ADDENDUM NO. 7

PROJECT NO. DGS C-1576-0010 PHASE 001
PROJECT TITLE - SCI Frackville - Electrical Upgrades
PROFESSIONAL:

PROJECT NO. DGS C-1576-0010 PHASE 1
PROJECT TITLE – SCI Frackville – Electrical Upgrades
LOCATION – Frackville, PA
Greenman Pedersen Inc, Scranton, PA 18505

DRAWN BY DATE
VS 09/15/2023
DRAWING No.
A2.3
CHECKED BY SCALE
M. BACARELLA AS NOTED

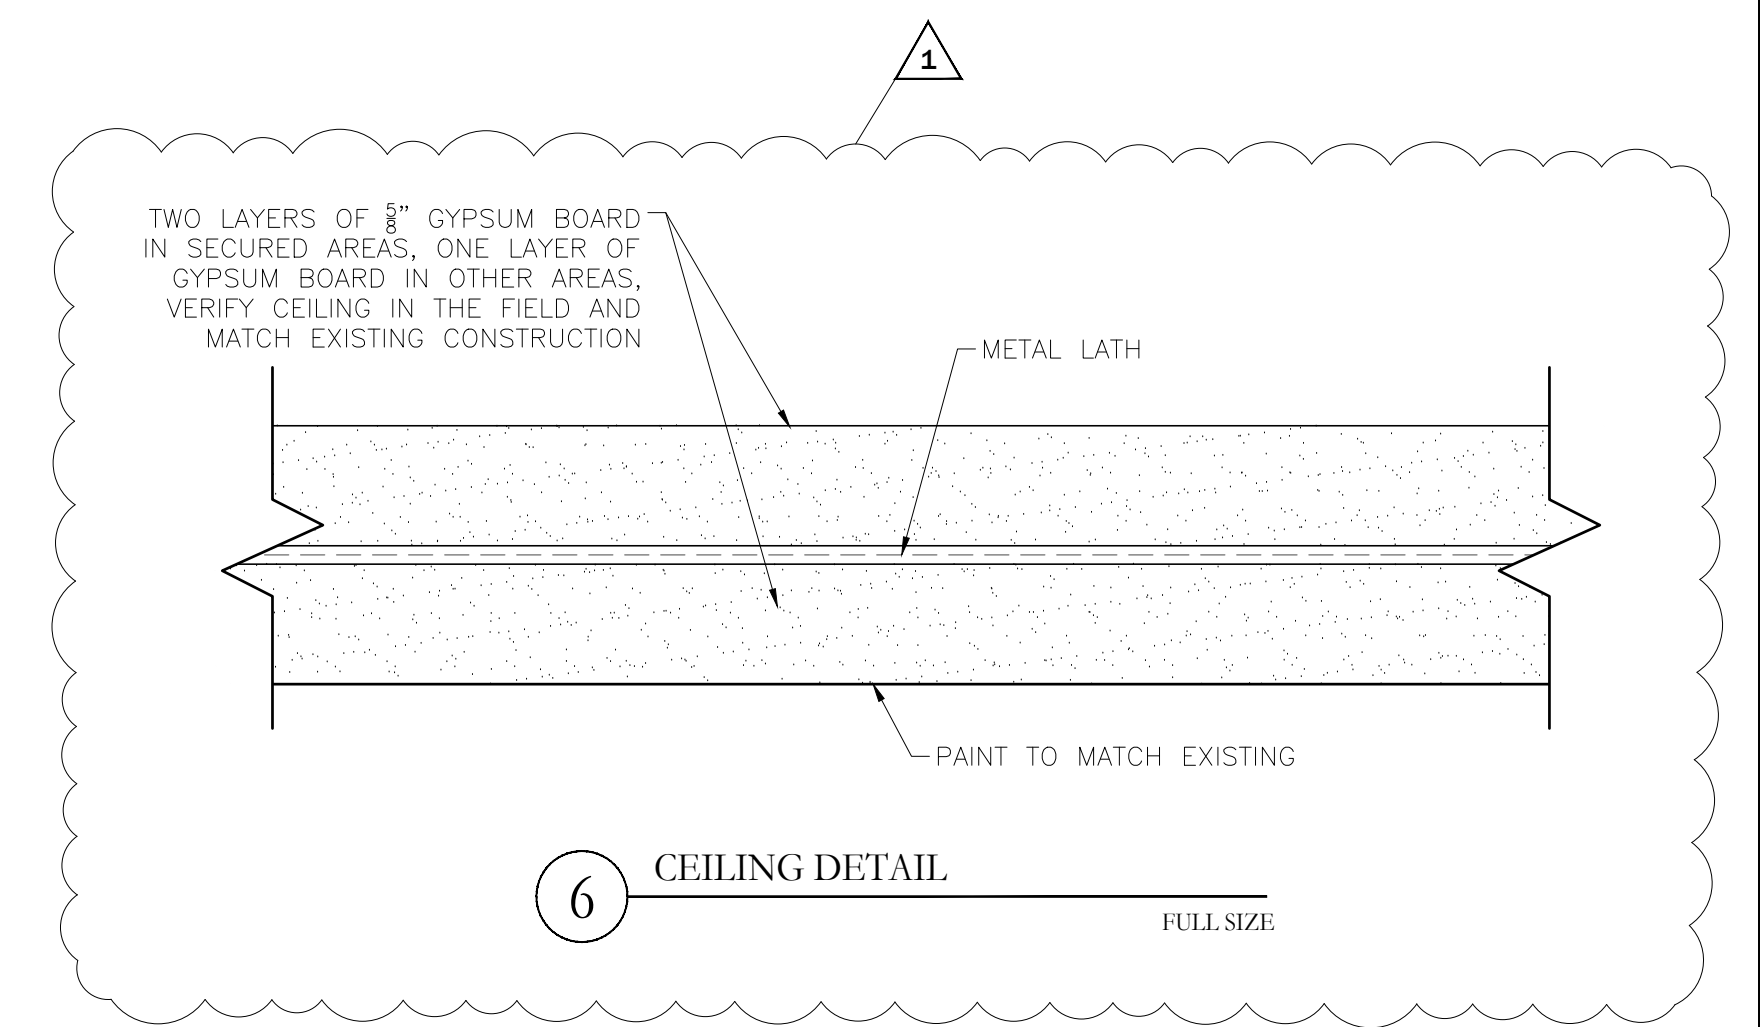
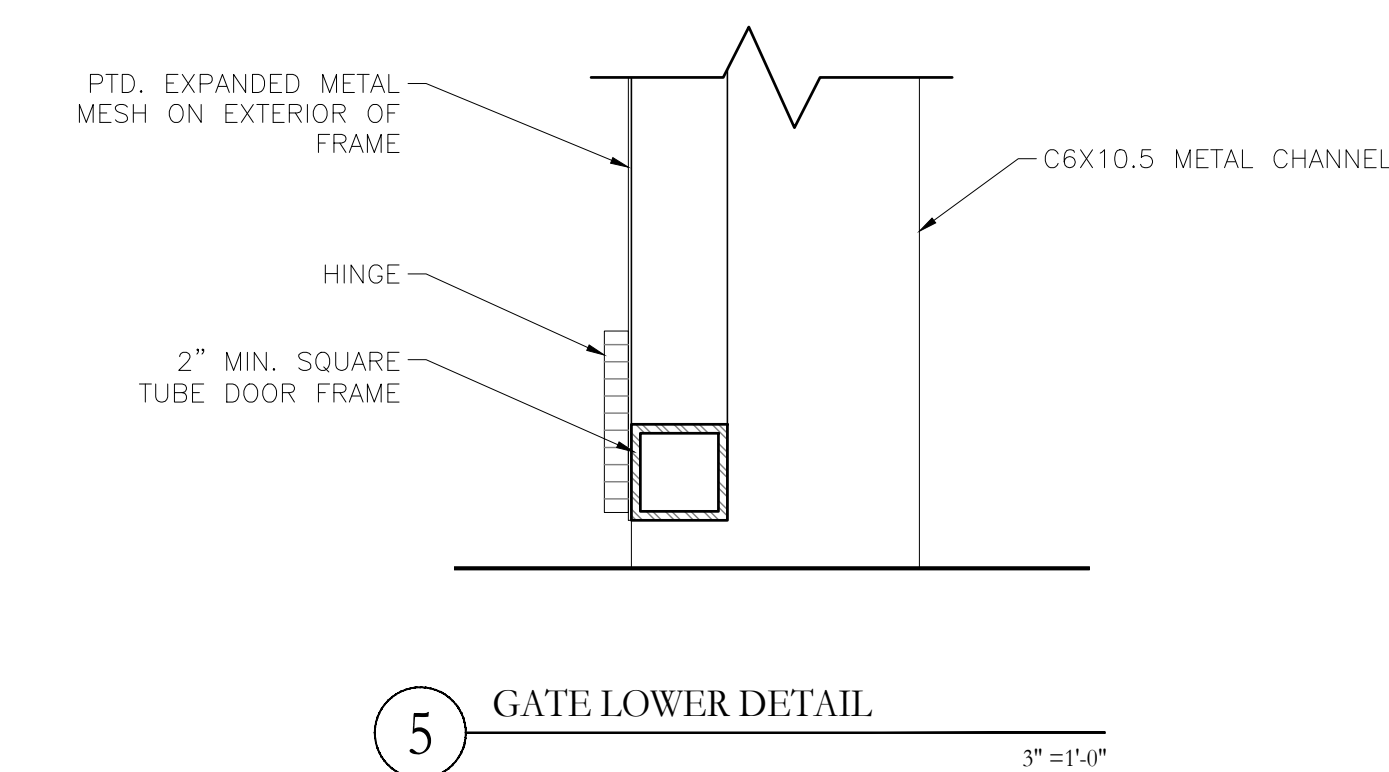
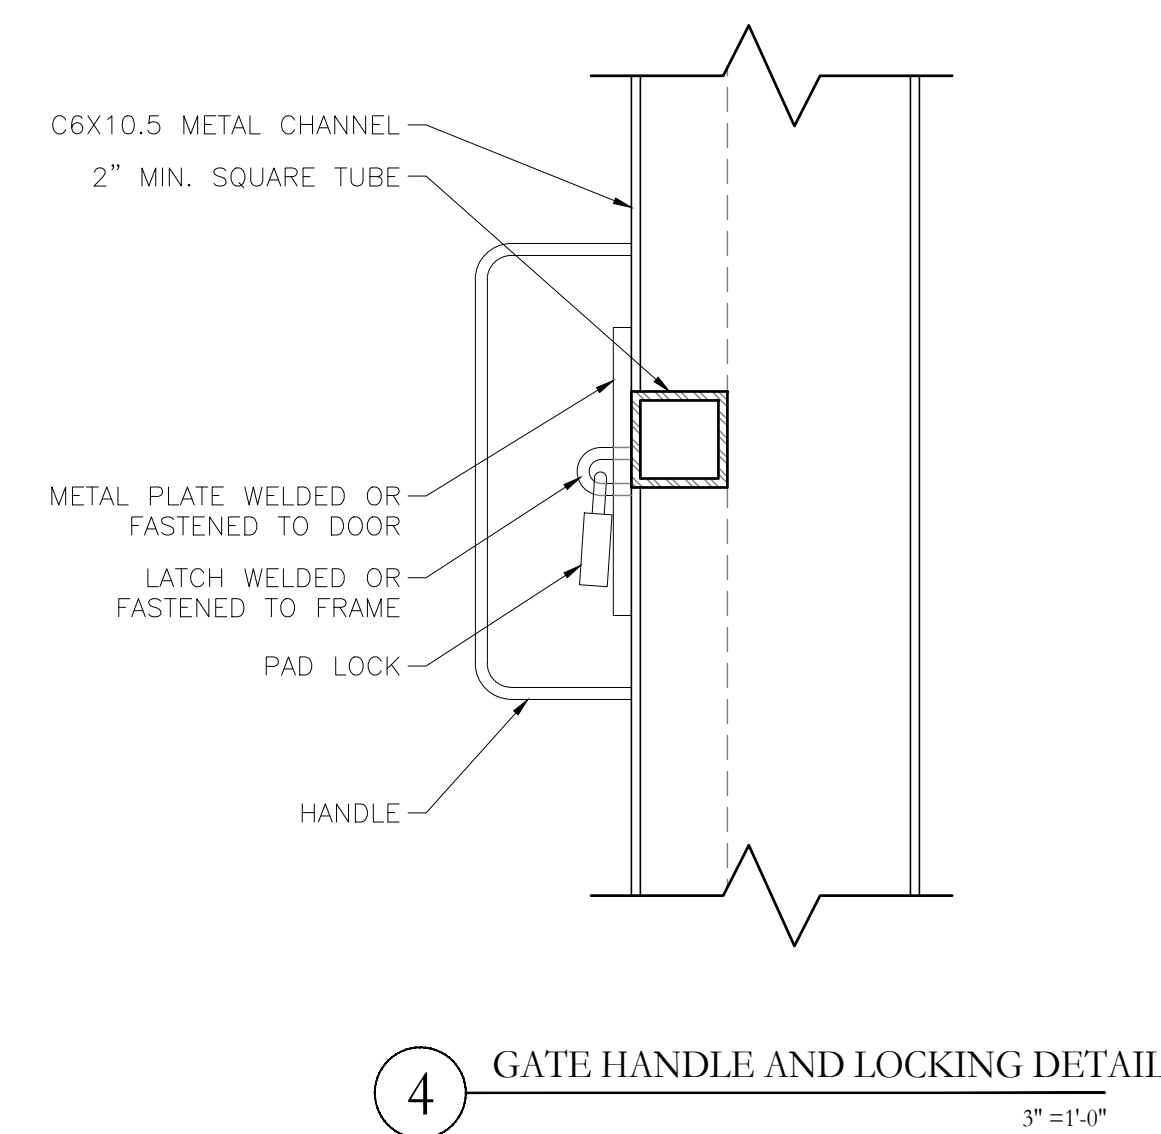
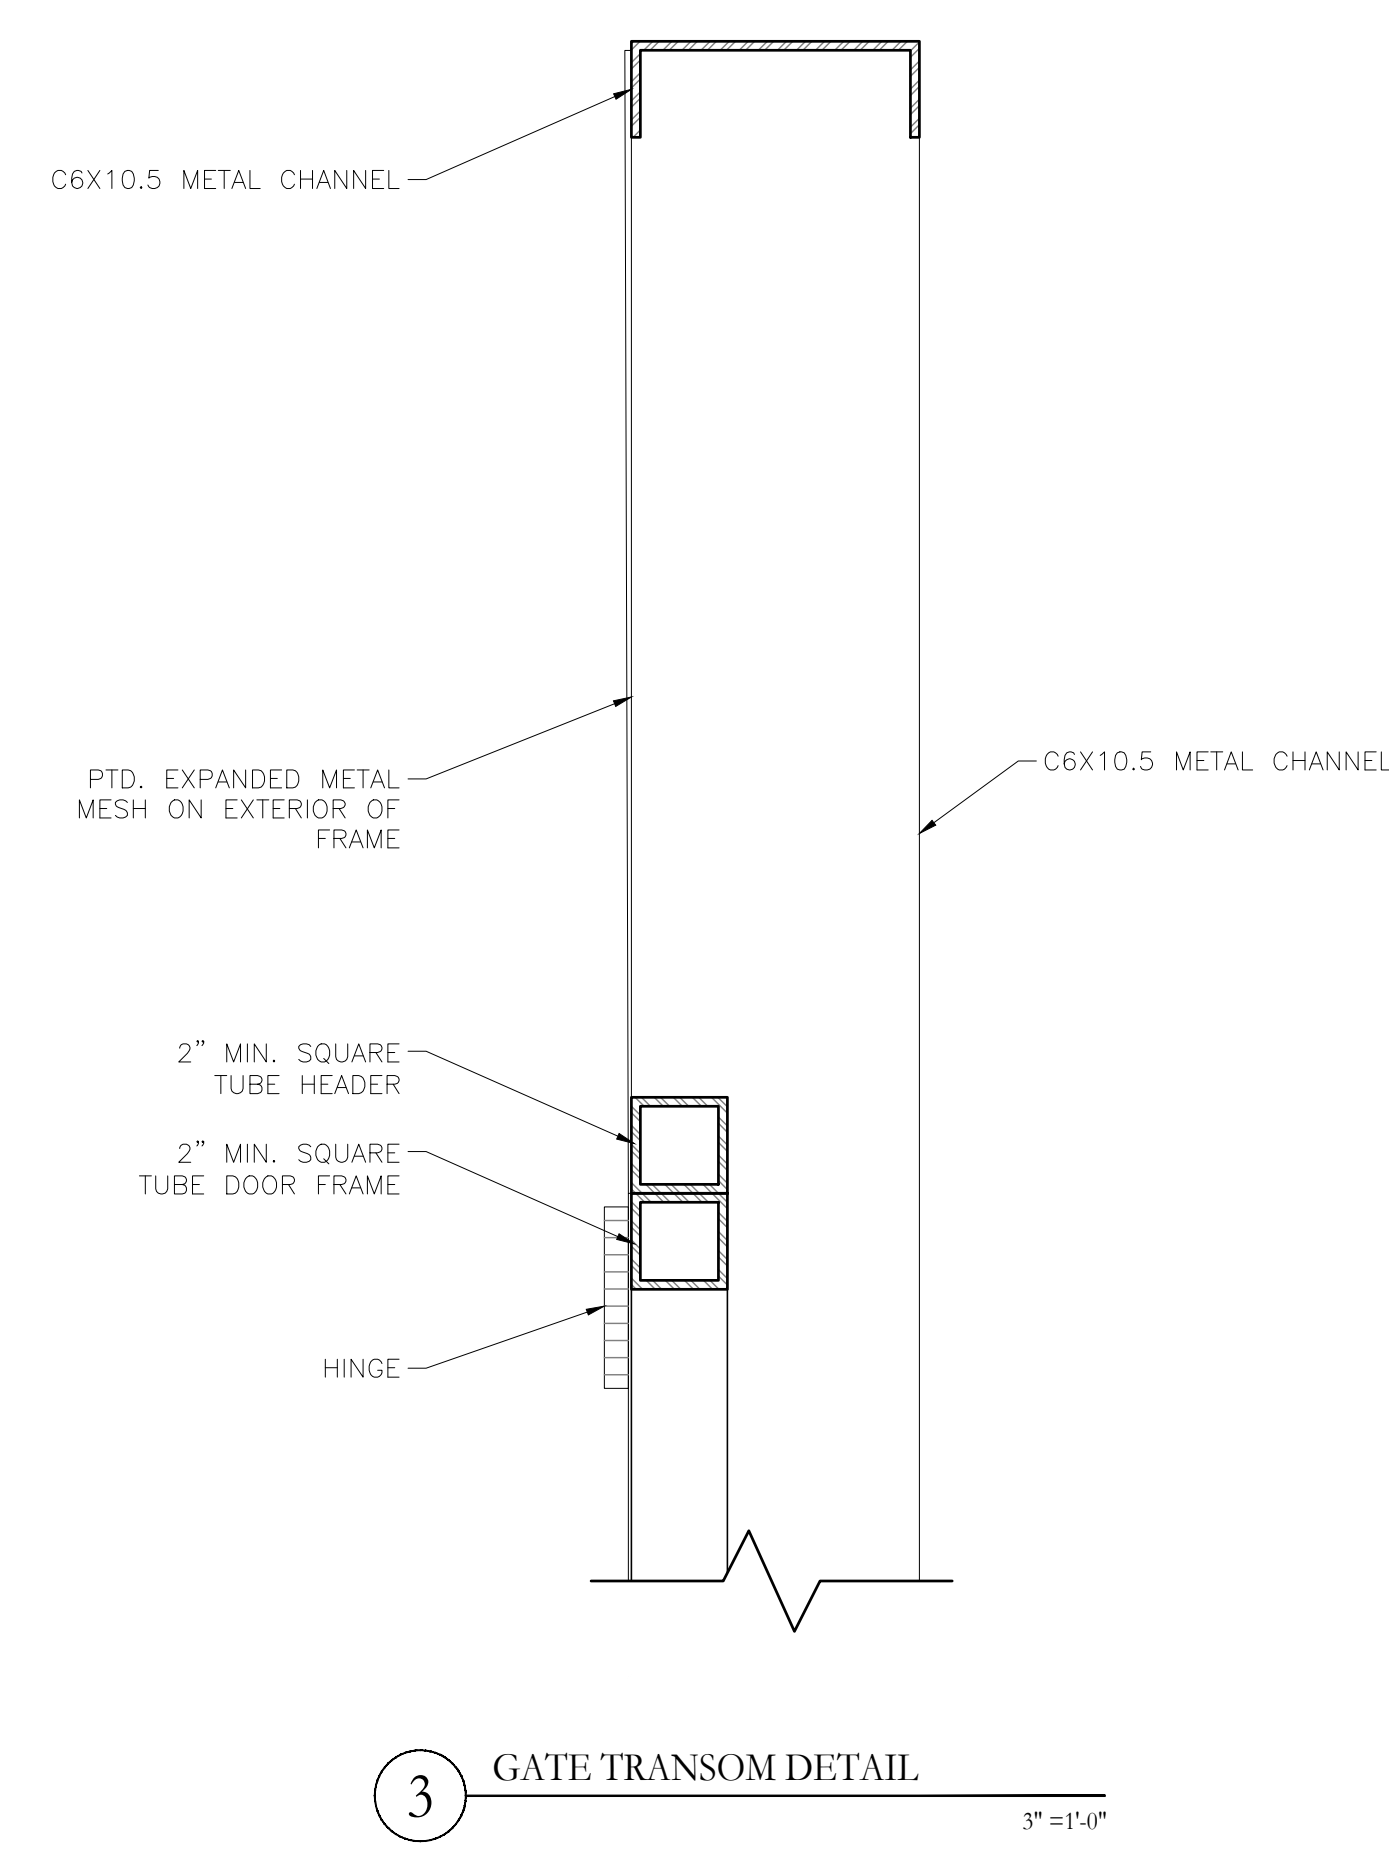
Item 2- Sheet A2.3: Added ceiling detail to sheet. See attached drawing.
